Customer Service Bulletin

January, 1997

SVT-CL/-2PRO

CUSTOMER SERVICE BULLETIN
 ADD CAP. & DIODES FOR
 "FAULT TRIPPING".

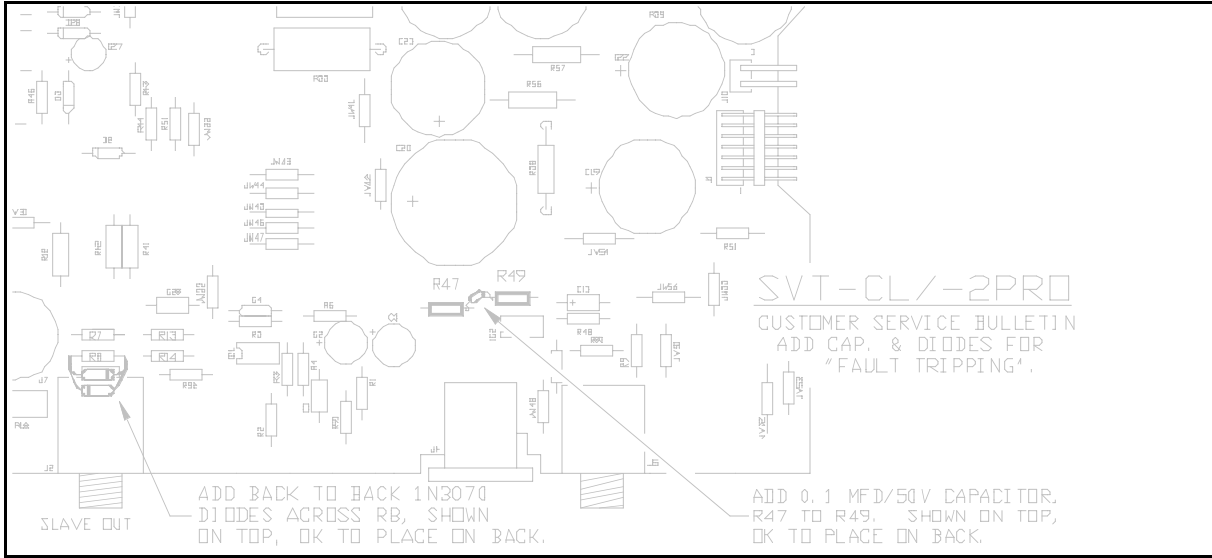
Some units may unnecessarily trip the protection circuitry and cause the unit to go into "fault" mode (i.e. flashing red and green power LED).

ADD BACK TO BACK 1N3070
 DIODES ACROSS RB, SHOWN
 ON TOP, OK TO PLACE ON BACK.

ADD 0.1 MFD/50V CAPACITOR,
 R47 TO R49. SHOWN ON TOP,
 OK TO PLACE ON BACK.

Install a .1 mfd/50V capacitor (part # 10A104-01) on the power amp board, as shown below.

Note: This Customer Service Bulletin (CSB) should be done in addition to the one released in March 1995 which added back to back diodes to the power amp input and also changed the gain resistor (R1 audio output PCB) to a 68K 1/4W. For reference the diodes are shown on the figure below. All future runs of these models will incorporate this update.
